Courts Plus

Courts Plus is the main fitness building for the park district. The main issues at this park are accessible parking being too sloped, slopes too steep, door opening forces too high, item out of reach ranges, no high low drinking fountains and exercise machines not having proper spacing next to them. **Please Note:** When a **UD** is indicated, this is a Universal Design (**UD**) recommendation to enhance accessibility. The **UD** recommendation is not required to meet the minimum accessibility standards but it would be encouraged.

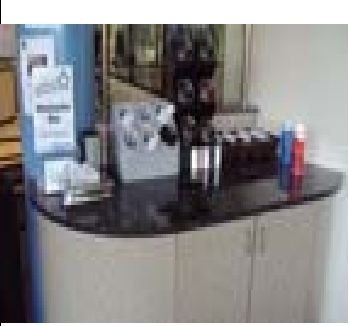
Photo	Barrier	ADAAG/IAC	Solution	Priority	By Whom	Projected Cost	Projected Date	Action Taken
	The emergency door out of the spinning class was alarmed but is assumed the opening force was too high.	IAC 400.310(j)(10)(B)(i)	Adjust the closer so the door opening force is no heavier than 8.5 lbs. to open and takes a minimum of 5 seconds to close or provide an automatic door opener at one of the doors.	1		\$ 100.00	2012	Readjusted to proper opening force \$25
	The door to the stairs across from the emergency door has an opening force too high at 15 lbs. and closes too quickly at 5 seconds.	ADAAG 404.2.8 & ADAAG 404.2.9	Adjust the closer so the door opening force is no heavier than 5 lbs. to open and takes a minimum of 5 seconds to close or provide an automatic door opener at one of the doors.	2		\$ 100.00	2012	Readjusted to proper opening force \$25
	The emergency door on the first floor was active with an alarm but is assumed the opening force was too high.	IAC 400.310(j)(10)(B)(i)	Adjust the closer so the door opening force is no heavier than 8.5 lbs. to open and takes a minimum of 5 seconds to close or provide an automatic door opener at one of the doors.	1		\$ 100.00	2012	Readjusted to proper opening force \$25

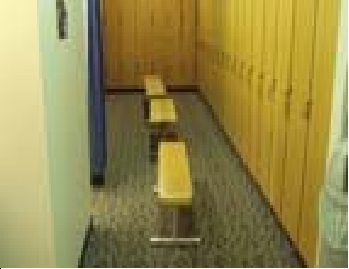
The sink in the women's locker-room has a knee clearance of only 21" because of the protective panel.	ADAAG 606	Reset the protective sink panel or remove the cabinet to provide the clear floor space, 27" knee clearance and install pipe protection.	3		\$ 850.00	2021

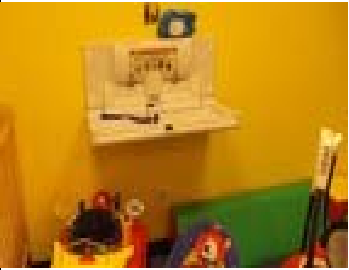
Photo	Barrier	ADAAG/IAC	Solution	Priority	By Whom	Projected Cost	Projected Date	Action Taken
	Items under the baby changing table do not provide the clear floor space required by someone to use this table.	IAC 400.320(w)	Relocate the items under the baby changing table to allow a person using a wheelchair to pull directly underneath.	3		NA	2012	Removed
	The girl's restroom toilet is positioned at 17" AFF and 19" to the centerline.	ADAAG 604.9	Depending on the age of the children the toilet should have a centerline of 12" and height of 11" to 12" for children ages 3 to 4, 12" to 15" and height of 12" to 15" for children ages 5 to 8 and a centerline of 15" to 18" and height of 15" to 17" for children ages 9 to 12.	3		\$ 750.00	2012	No longer in use

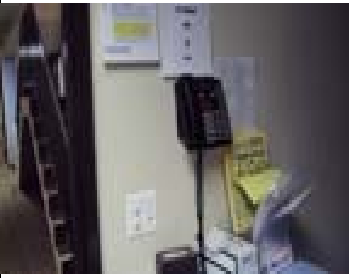
Photo	Barrier	ADAAG/IAC	Solution	Priority	By Whom	Projected Cost	Projected Date	Action Taken
	The emergency door out of the baby room had an alarm on but it is assumed it has an opening force too high.	ADAAG 404.2.8 & ADAAG 404.2.9	Adjust the closer so the door opening force is no heavier than 5 lbs. to open and takes a minimum of 5 seconds to close or provide an automatic door opener at one of the doors	2		\$ 100.00	2012	Adjusted opening force
	The brochure holder for the tennis information is mounted too high at 59" and 72". The nomination form box is mounted too high at 54"	ADAAG 308	Lower the brochure/flyer and the nomination form box holder to be at 48" AFF.	4		\$ 100.00	2012	Removed
	The drinking fountain is mount at 41 1/2" to the spout and 32 1/2" knee.	ADAAG 211 & ADAAG 602	Provide one individual drinking fountain at a wheelchair height or a single hi-lo drinking fountain that provides a wheelchair accessible fountain with a spout at 36" maximum and a standing drinking fountain with a height between 38" minimum and 43" maximum. The toe clearance should be a minimum of 9".	4		\$ 2,125.00	2012	Mounted to proper height

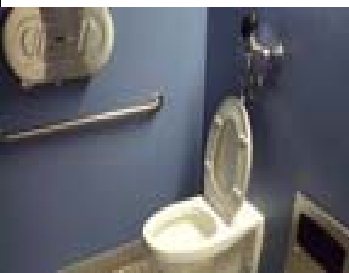
Photo	Barrier	ADAAG/IAC	Solution	Priority	By Whom	Projected Cost	Projected Date	Action Taken
	The phone is mounted too high at 56".	ADAAG 308	Remount the phone to provide a reach range no higher than 48" AFF for a forward reach over an obstruction no deeper than 20" or a side reach of 48" AFF over an object no deeper than 10".	2		\$ 150.00	2019	
	The door to the ADA courts has an opening force too high at 25 lbs.	ADAAG 404.2.8 & ADAAG 404.2.9	Adjust the closer so the door opening force is no heavier than 5 lbs. to open and takes a minimum of 5 seconds to close or provide an automatic door opener at one of the doors.	2		\$ 100.00	2019	
	The drinking fountain at the courts is mounted at 40 1/2" to the spout.	ADAAG 211 & ADAAG 602	Provide one more individual drinking fountain at a wheelchair height or a single hi-lo drinking fountain that provides a wheelchair accessible fountain with a spout at 36" maximum and a standing drinking fountain with a height between 38" minimum and 43" maximum. The toe clearance should be a minimum of 9".	4		\$ 2,125.00	2024
